CONTRACT NO. 1797

OHIO RIVER TUNNEL

ADDENDUM No. 5

All bidders bidding **Contract No. 1797** shall read and take note of this **Addendum No. 5**. The Contract Documents for **Contract No. 1797 – Ohio River Tunnel** are hereby revised and/or clarified as stated below.

O41-ST-226
SMRT-O41-VD PLANS AND SECTIONS

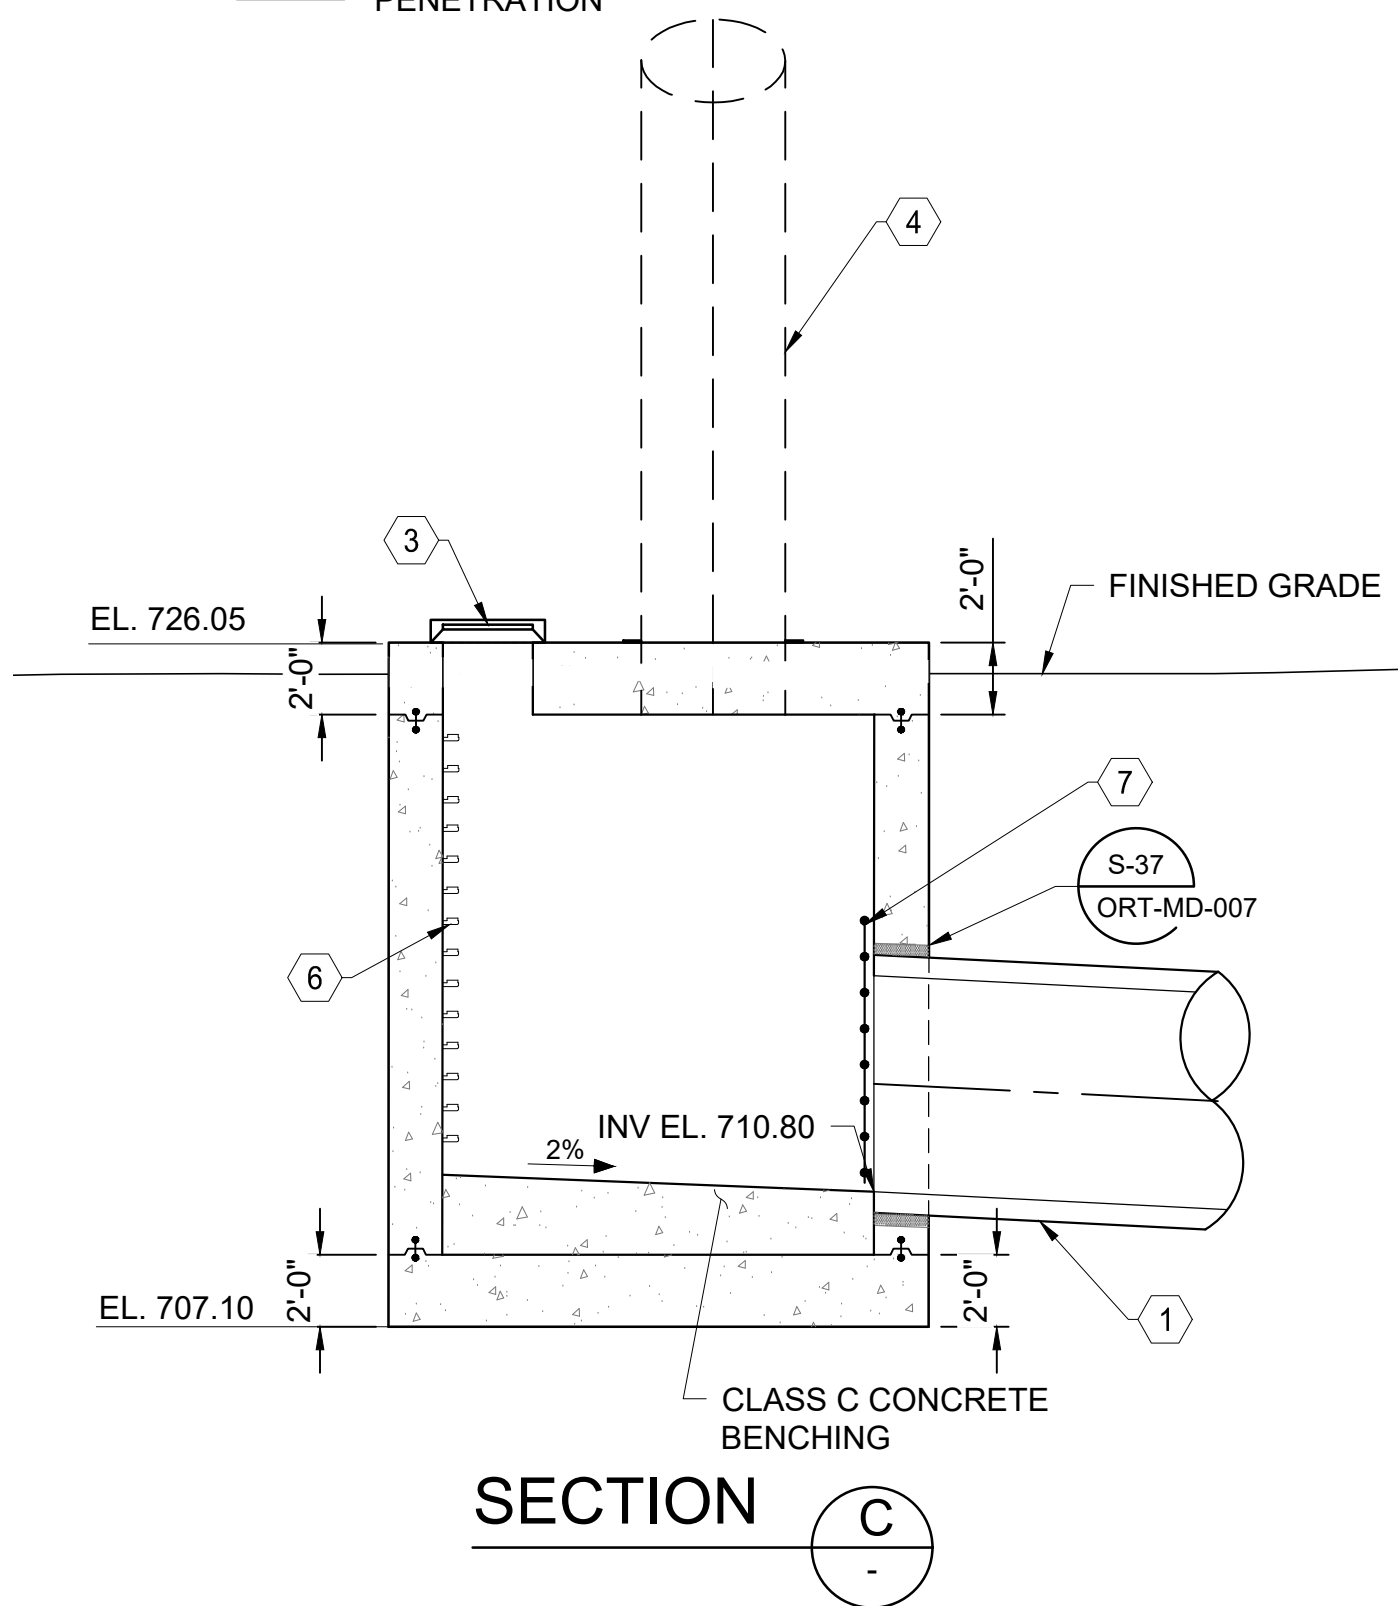
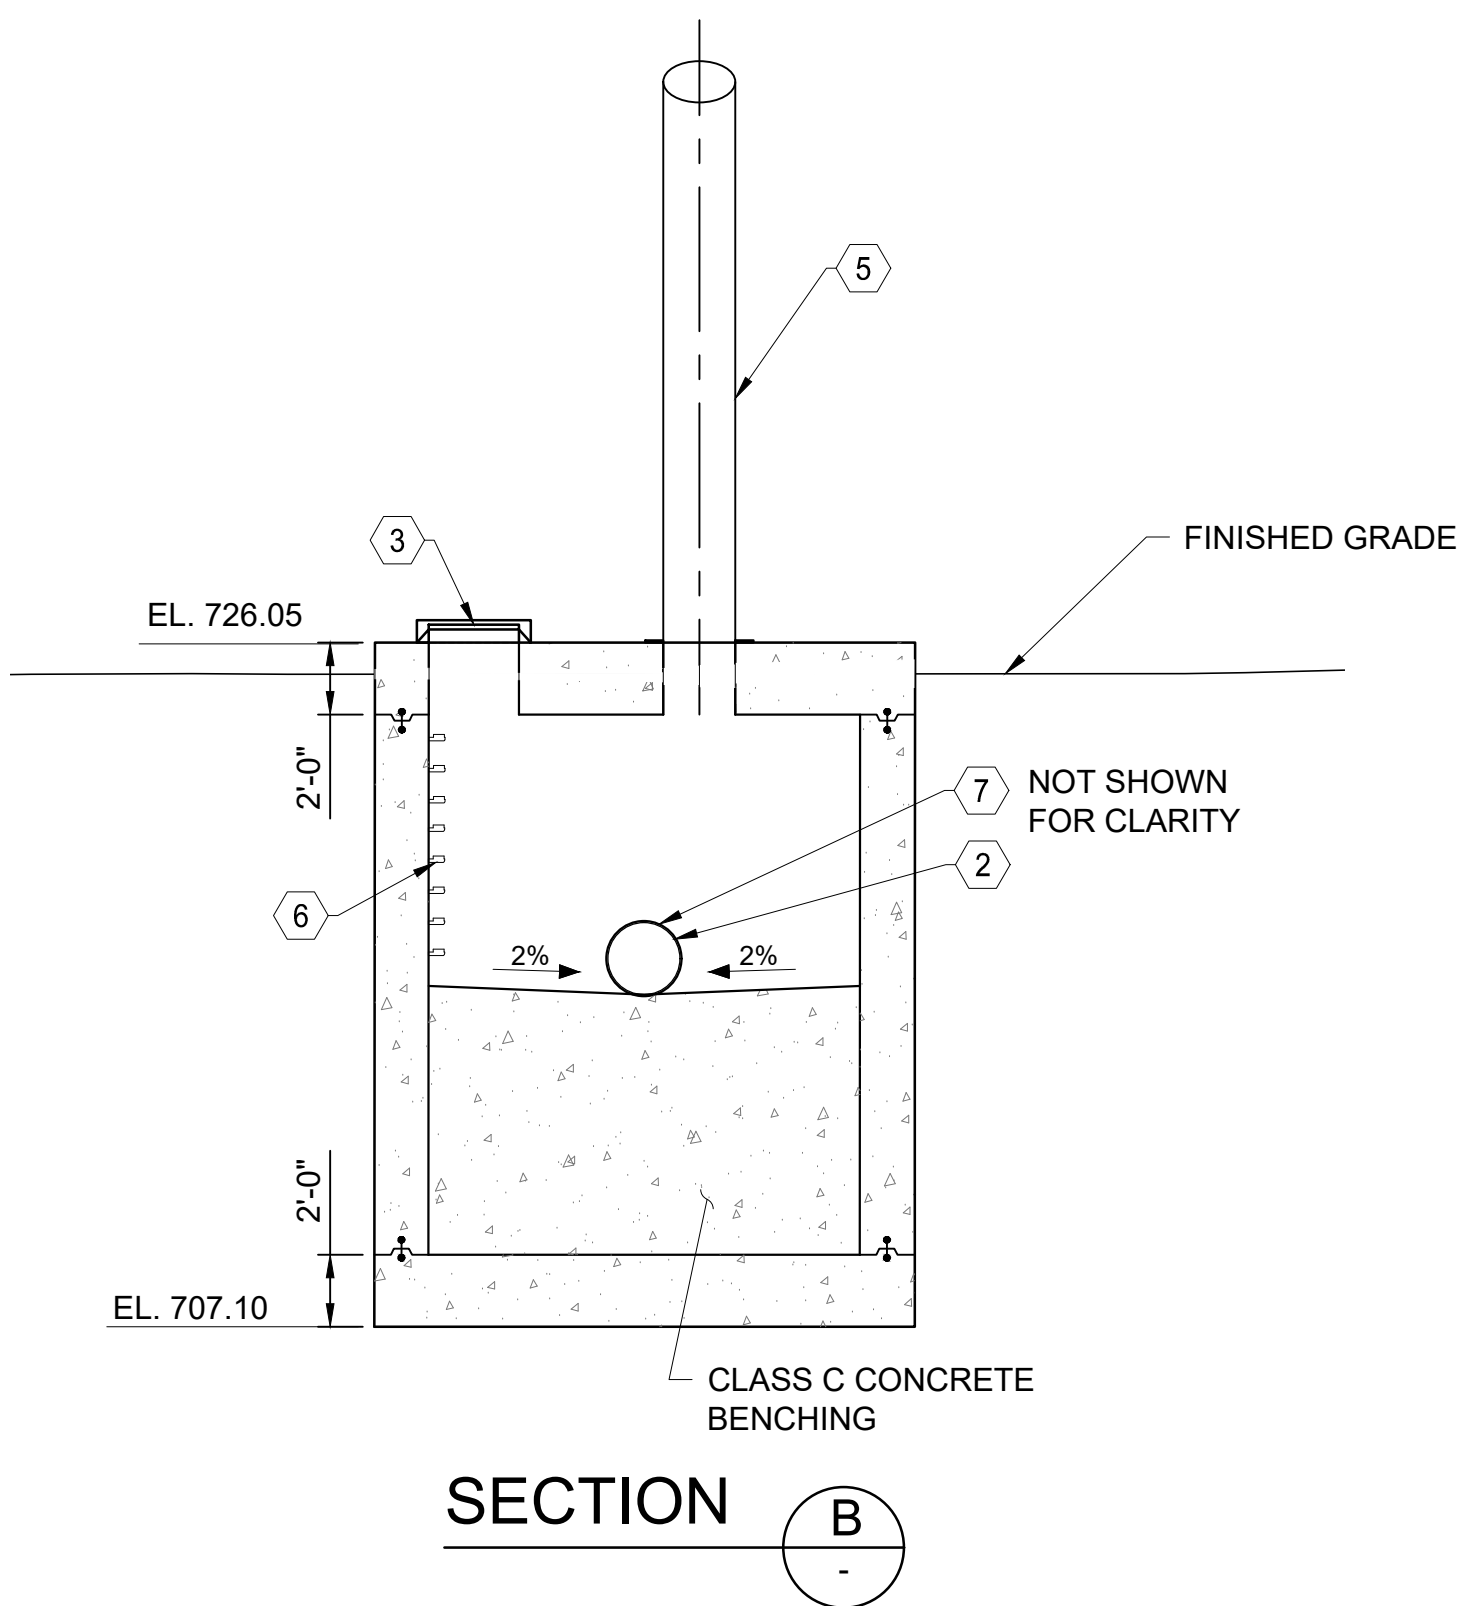
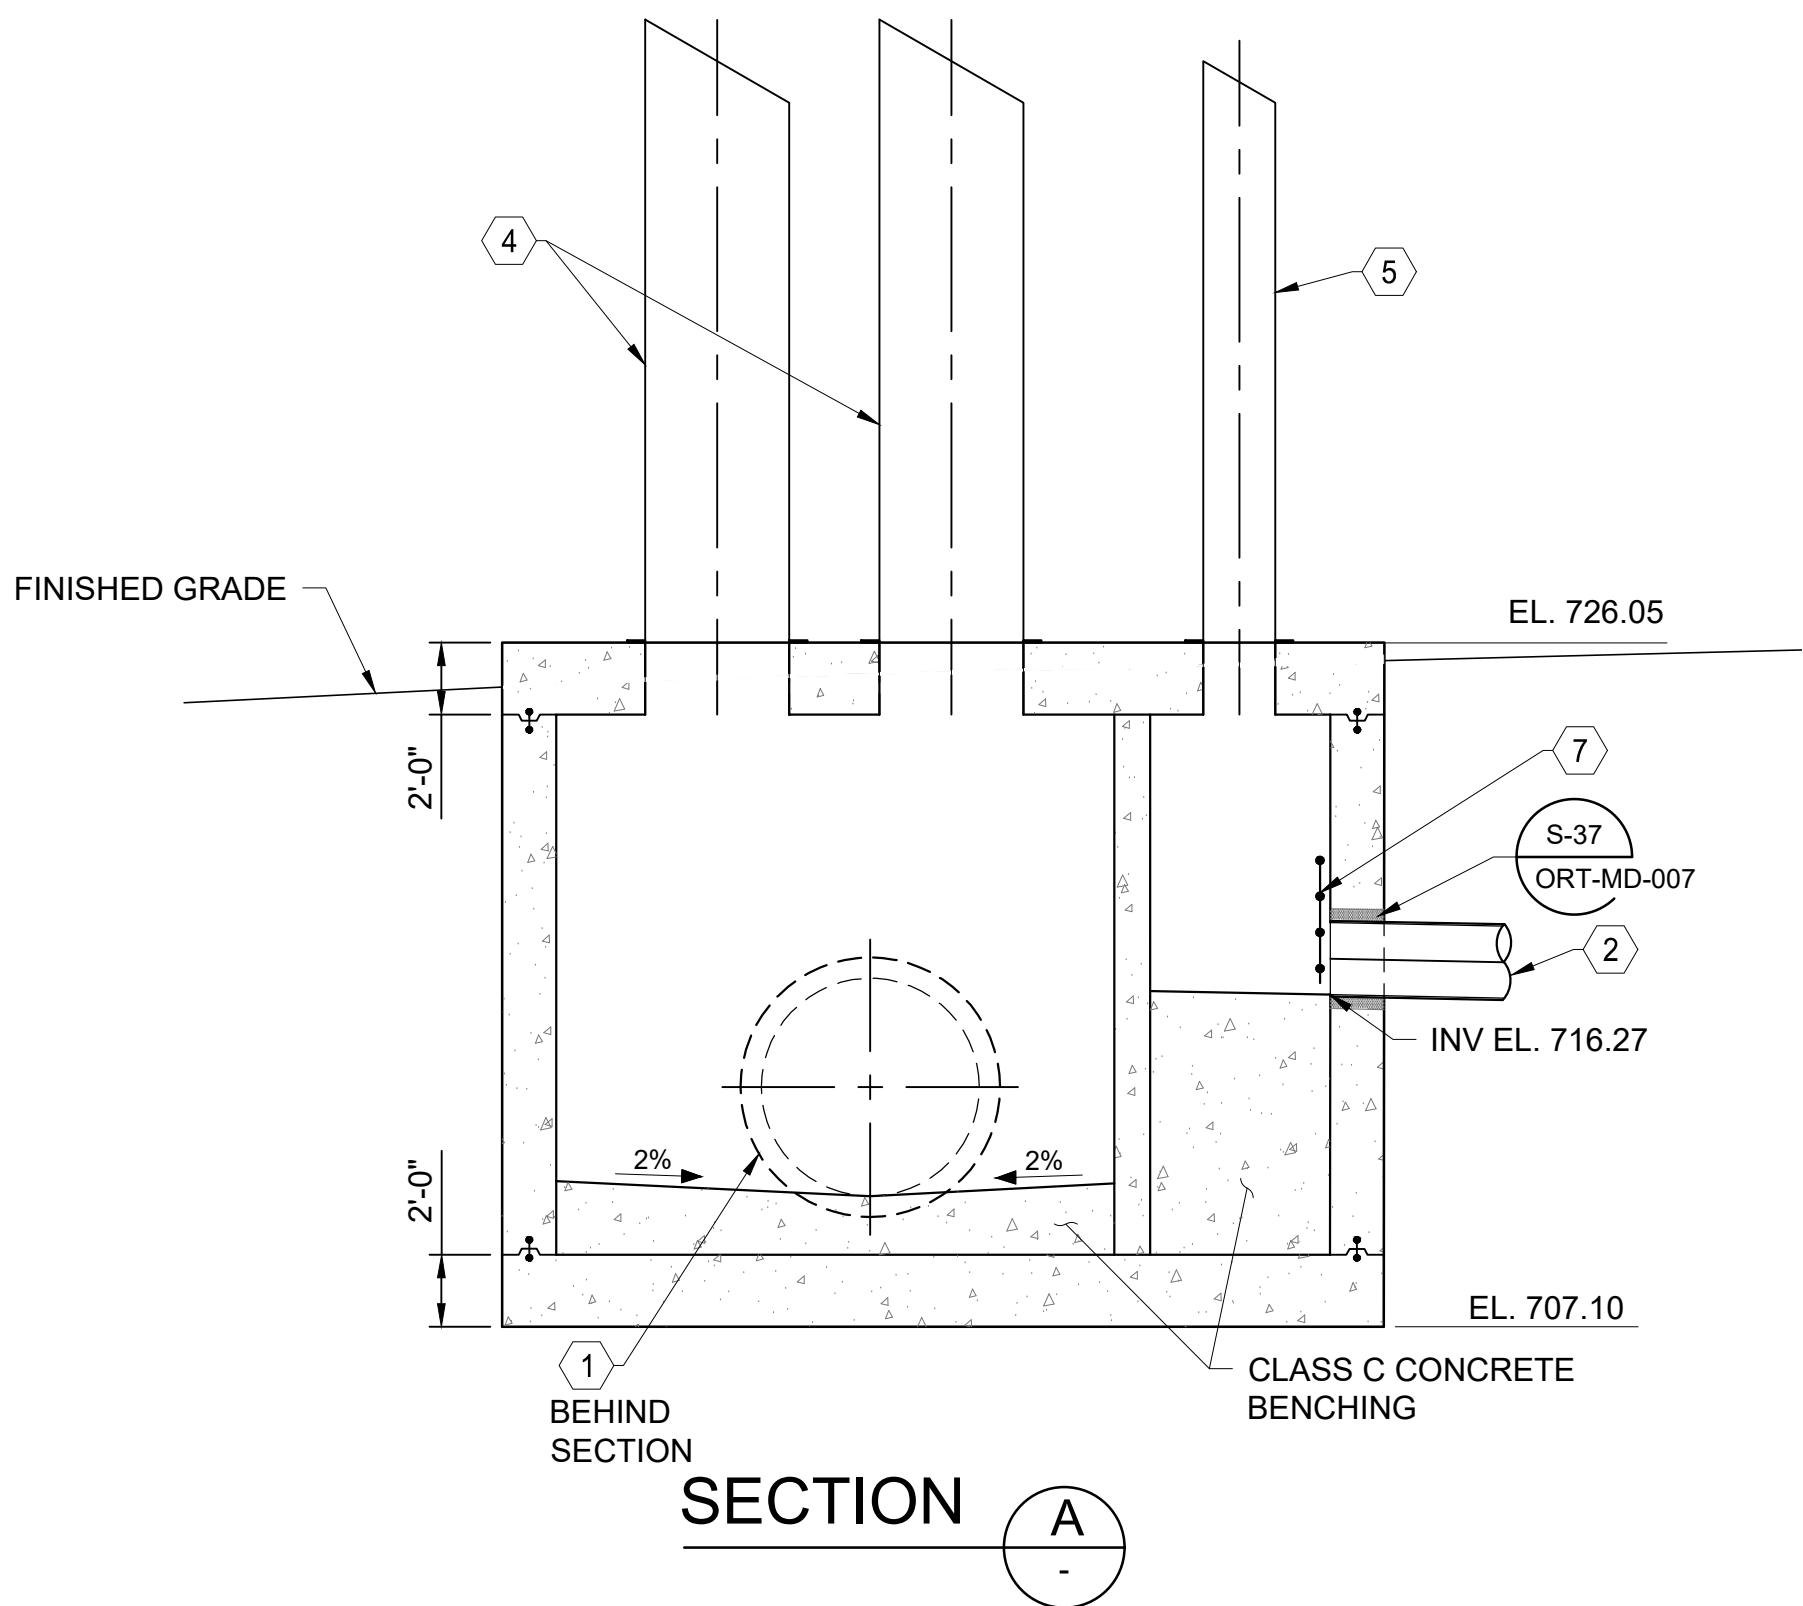
- A2 **This is a dedicated full-time position.**
- Q3 *Ventilation Diffuser SOE - For all sites that contain ventilation diffusers, a support of excavation design is to be designed by the contractor, and submitted to the owner for review and approved. The contract drawings reference in the support of excavation notes under note C, "Any excavation for the ventilation vaults deeper than 4 feet shall be supported by a temporary excavation support system without internal bracing or any elements of the SOE system intruding into the excavation footprint."*

- Please remove these internal bracing restrictions to allow the Contractor and their Engineer to determine the best solution for shoring these excavations.*

- A3 **Drawings O27-ST-142, O27-ST-143, O41-ST-226, A48-ST-315, A58-ST-438, A58-ST-440 O14-ST-628, O07-ST-713, O06A-ST-814, and O06A-ST-815 are revised and attached to this Addendum. See CHANGES TO CONTRACT DOCUMENTS section below and Attachment A of this Addendum.**

- c) DELETE O41-ST-226 (Sheet 341 of 770) and ADD Revised O41-ST-226 (Sheet 341 of 770), which is Attachment A to this Addendum.
- d) DELETE A48-ST-315 (Sheet 376 of 770) and ADD Revised A48-ST-315 (Sheet 376 of 770), which is Attachment A to this Addendum.
